Rezoning Transportation Analysis

Petition Number: Zoning Petition #2021-011

General Location Identifier: Tax ID 10304127

Date	Description
02-25-21	First Review (WB)

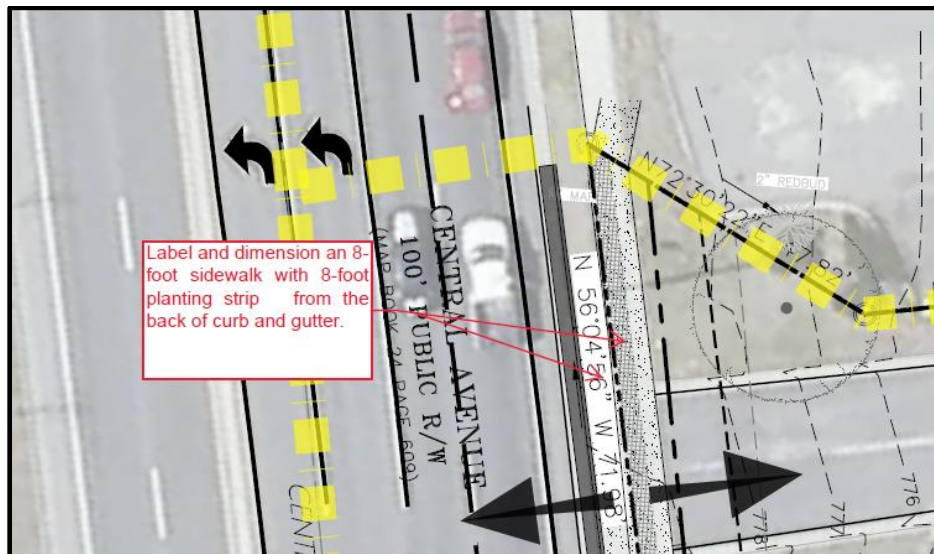
1. **Curblines:** The proposed zoning district has a setback measured from back of the existing or proposed future curblines.
 - a. **Central Avenue:** Location of curb and gutter needs to be at 38 feet from the centerline to allow for a 4+ Avenue with an 8-foot buffered bike lane.

Label and dimension the curb and gutter from the road centerline on the site plan.
